Subject: Response to comments received on the Coleman Soccer Fields Project, File No. PP10-155, dated 11/22/2010.

Re: City of San Jose's Mitigated Negative Declaration-Coleman Soccer Fields; SCH# 2010112041

RE: File No. PP10-155, Initial Study for the Coleman Soccer Fields

TEXT REVISIONS TO FINAL INITIAL STUDY/MITIGATED NEGATIVE DECLARATION - COLEMAN SOCCER FIELDS

150' Spill
Coleman Avenue Soccer Complex
San Jose,CA

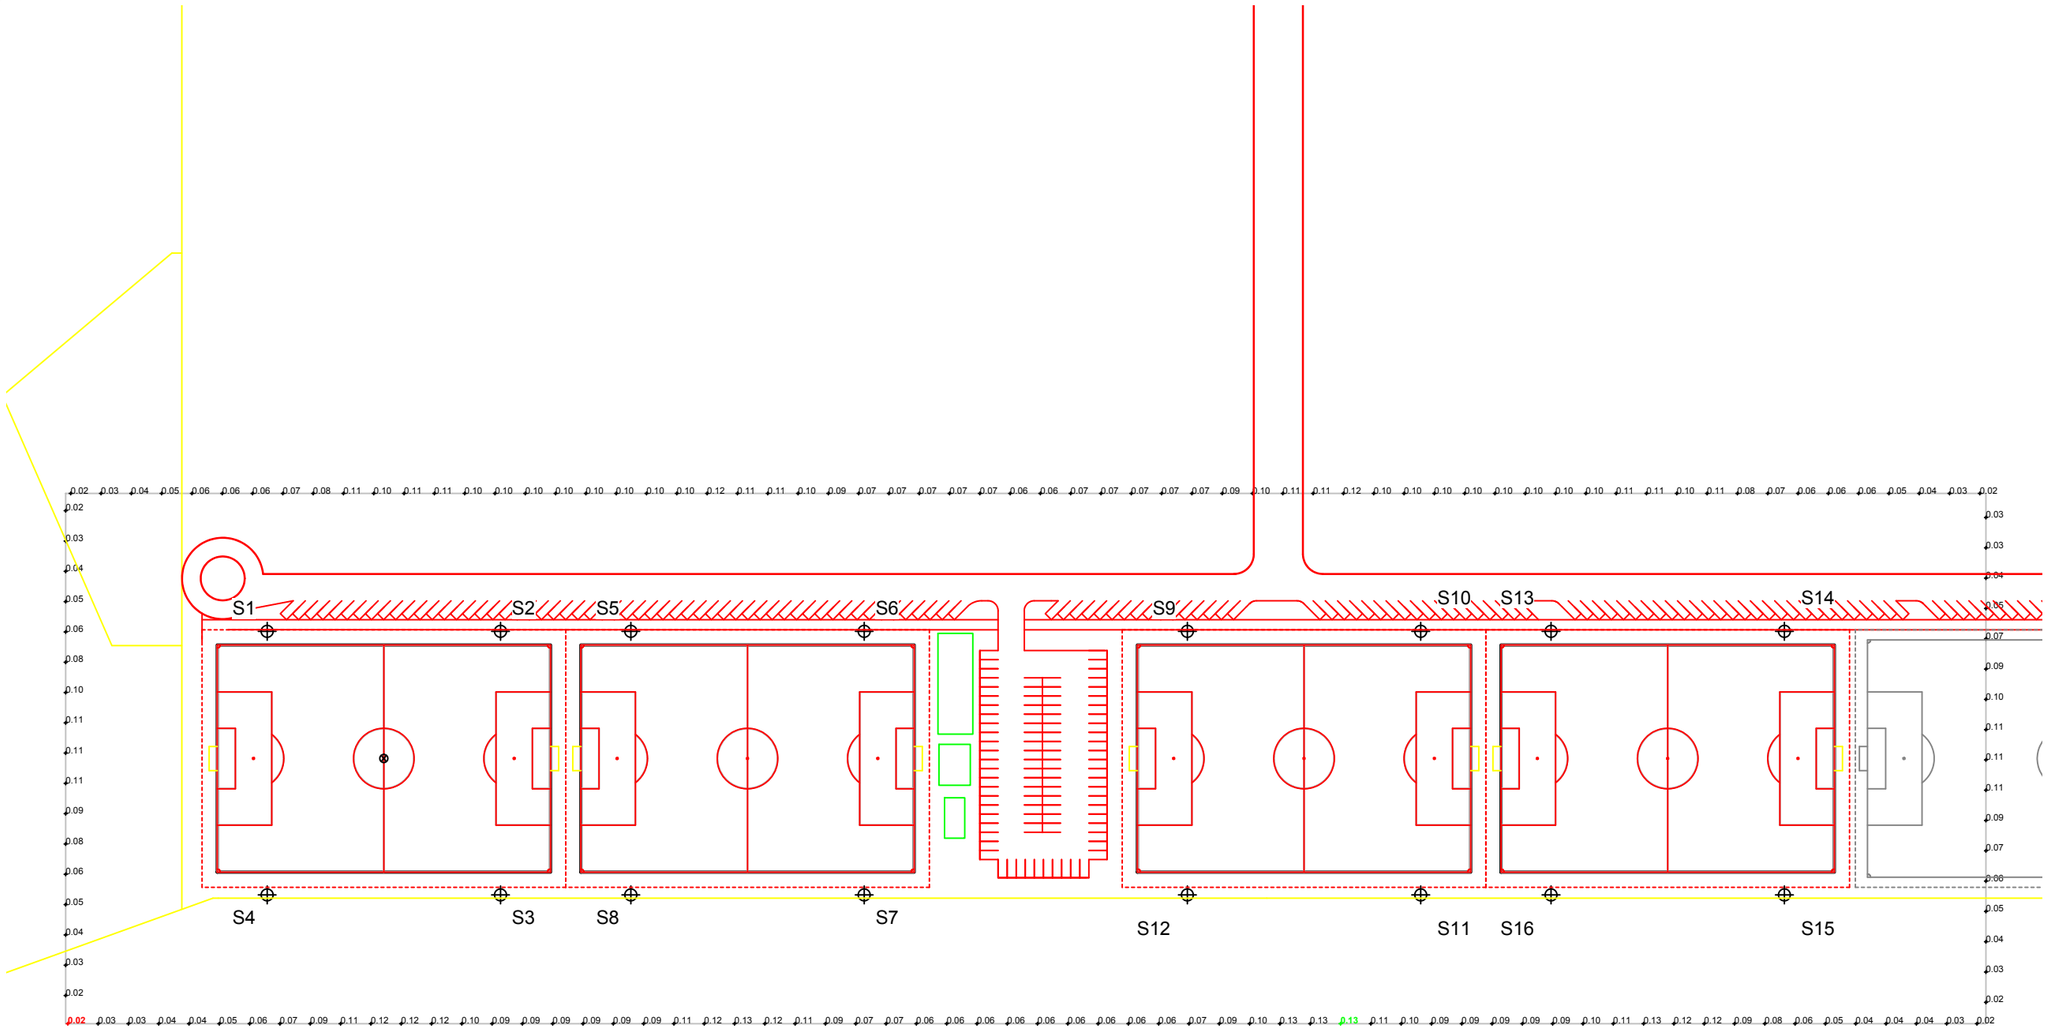
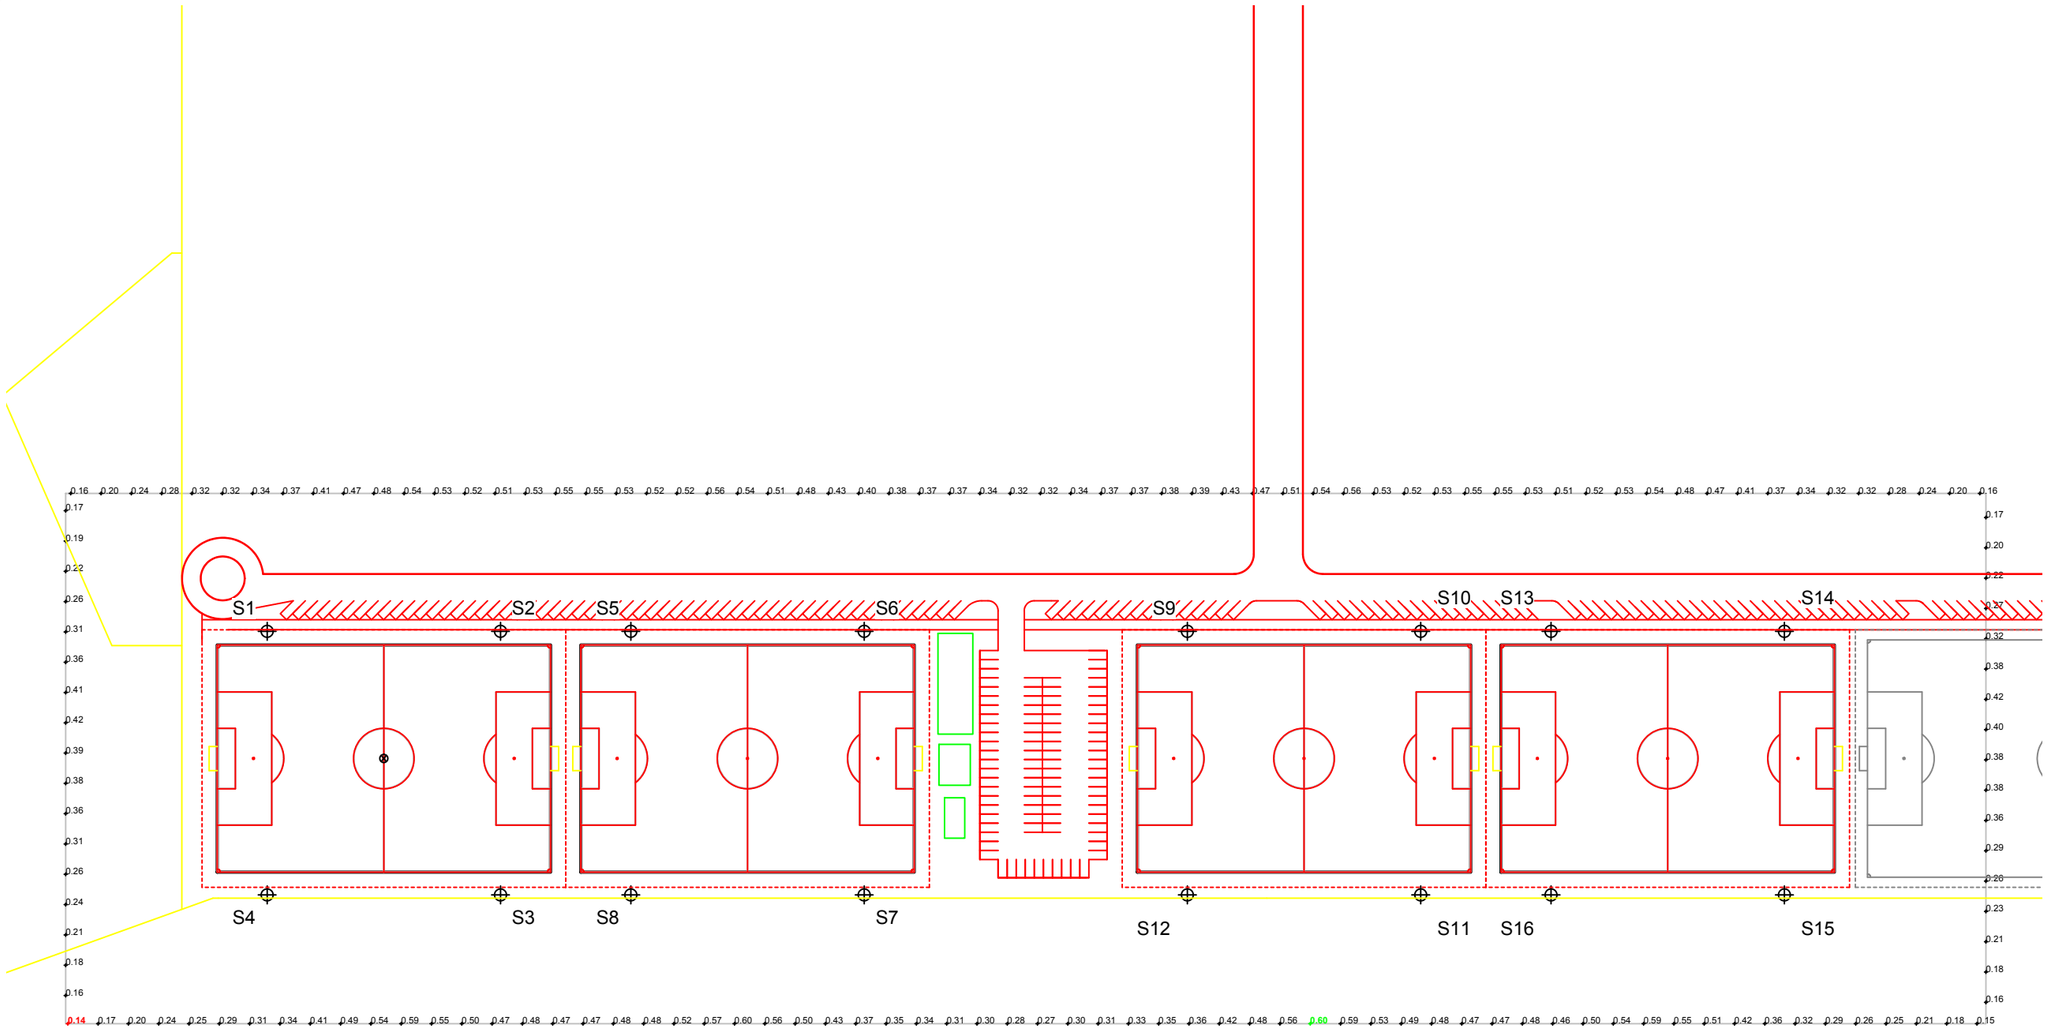
- The lighting study included in the IS does not address the impact of glare on neighboring residential uses. The City of San Jose Draft EIR on the Airport West project (September 2009) states on p. 73: "These same features also restrict a person from seeing the arc tube (i.e., brightest component of the light) from areas surrounding the stadium." Based on the lighting study and any needed subsequent analysis, which residences along the Campbell Ave corridor would be impacted by having a clear view of the arc tube of the proposed lighting systems?

As described in the IS, the proposed night lighting of the soccer fields will increase the ambient night light levels in the immediate area; however, this light will not significantly adversely affect day or nighttime views in the area, based on the distance to sensitive receptors and the lighting plan that includes shielding and design to minimize spillover light. An illumination study was prepared for the project as described on page 11 of the IS. A diagram showing the spillover light was prepared for the project and is attached.

Figure
2

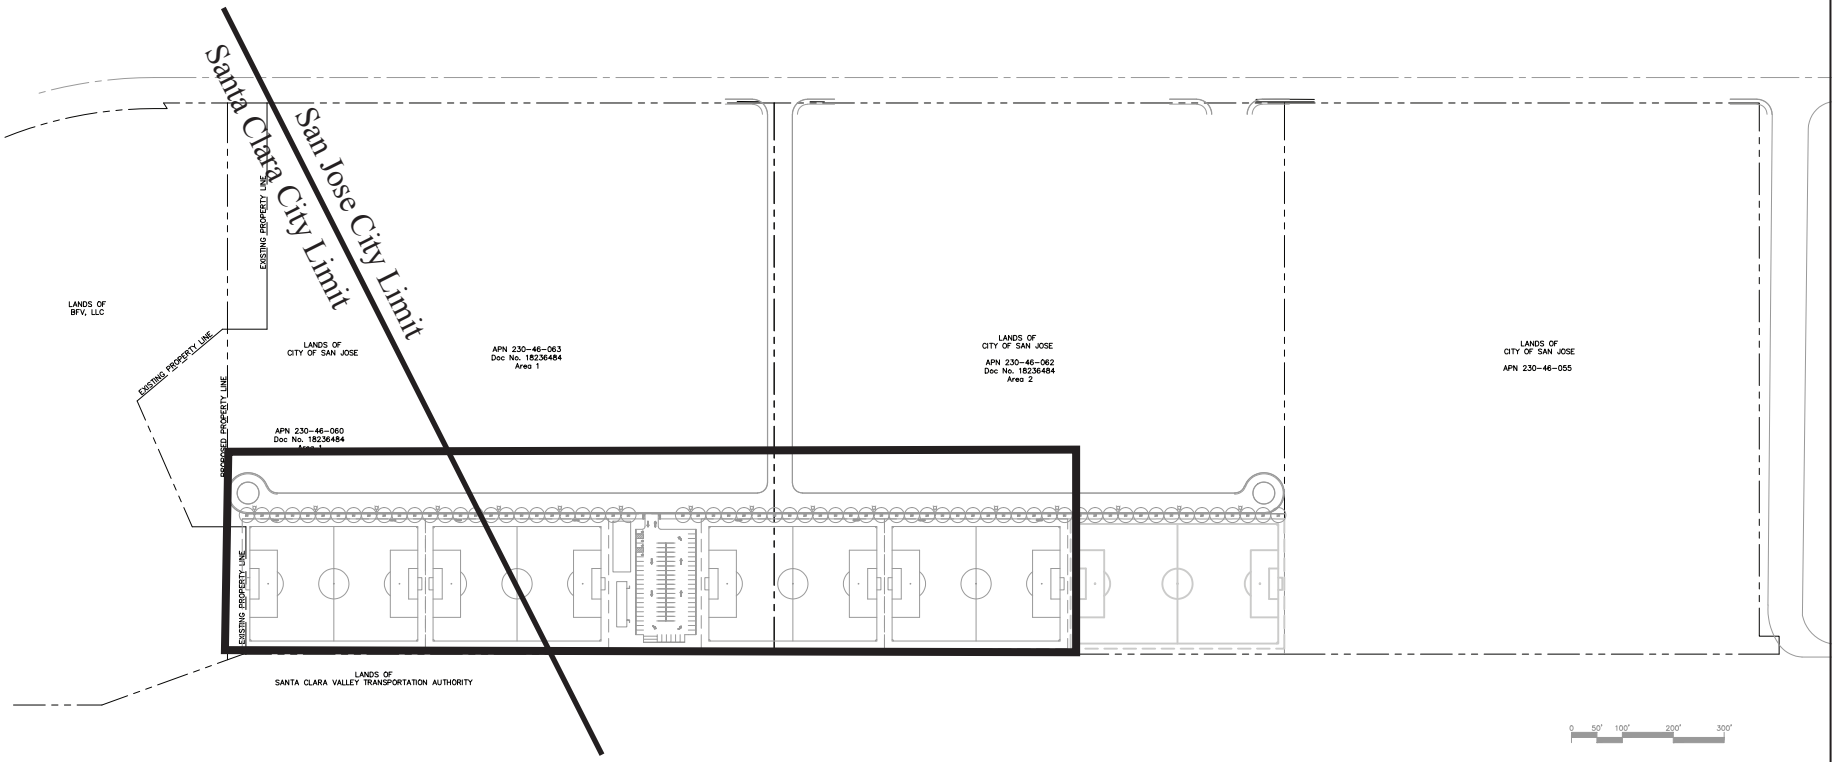
Figures 2 through 4 should show city limit boundaries for Santa Clara/San Jose on the illustrations. 3

3. These figures will be revised in the Final IS to show the City of Santa Clara boundaries (see attached).

Pages 5, 6, and 7, Figures 2-4 have been revised as shown in the attached materials.
